REFERENCE NO: RF-24-09

SUBJECT: *UPDATE* CHECK ENGINE LIGHT ON WITH DTC P0126:00

- 1. Thermostat
- 2. Thermostat cover gasket
- 3. Thermostat cover
- 4. Water outlet gasket

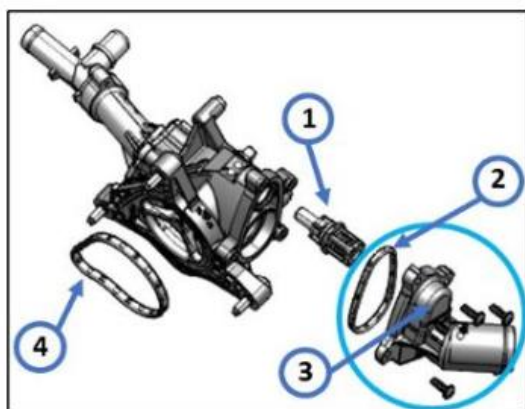
A new repair procedure has been developed to address DTC P0126:00 on SKYACTIV-G 2.0/2.5L engines (non-turbo). Mazda has introduced a replacement kit of the thermostat located within the Coolant Control Valve (CCV).

NOTE: It is no longer necessary to replace the CCV for this DTC.

This new repair is outlined in TSB 01-005/24, which will replace the current TSB 01-005/23. Sales orders for the new kits are available through the LPO screen on eMDCS.
